**Bayside Planning Panel**

Application Type Development Application – Mixed Use Development (Commercial

**Application Number** DA-16/237

## Planning Assessment Report

Figure 1: Section Plan demonstrating height non-compliance (highlighted in yellow)

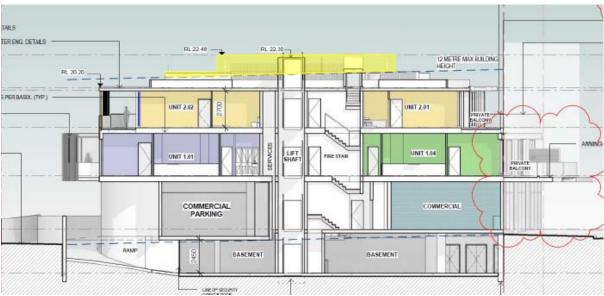
In regards to the height of the development, the proposal protrudes 1.55 metres above the maximum height of 12 metres with a total height to the top of the lift overrun and pergolas at 13.55m. This is a variance of 12.9%. The applicant has submitted a Clause 4.6 variation to the standard which is discussed below in the report. The remaining issues have also been discussed in greater detail below.

As indicated, the height non-compliance is limited to the lift overrun and pergola. The proposed development is however considered to be generally consistent with the scale of development expected at the site.

Figure 11: Reproduction of Figure 20 from Part 5 of BBDCP2013

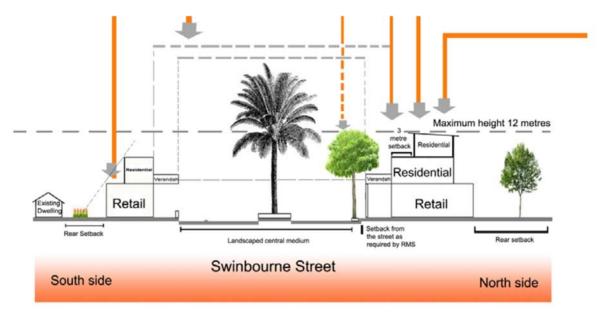
C4 The design of development must be generally consistent with the Desired Future Character of the centre identified in Figure 20	The proposal complies and has been designed to reflect Figure 20 within the Desired Future Character section of the DCP.	Yes
applies under BBLEP 2013.  Notwithstanding the 12 metre height limit, a maximum height of two stories applies along the street frontage with a third level permitted which is setback from the street frontages and the rear. The setback from the rear is to be determined following a detailed site analysis at development application stage and must satisfy Council that the amenity of neighbouring residential properties are protected in terms of sunlight and natural daylight access, privacy and visual amenity. Applicants must therefore demonstrate at development application stage that impacts on the residential area are minimised.	The proposal exceeds the height of the development with the lift overrun and the pergola protruding by 1.55m above the height requirement. This has been discussed in Note 3 above. Notwithstanding, the second floor has been setback away from the side boundaries. A visual privacy analysis has been carried out by the applicant from the balconies on the second and first floor to the north of the site to demonstrate whether any negative overlooking onto the neighbouring residential properties will occur. From the plan, the development is acceptable.	No – Refer to Note 3
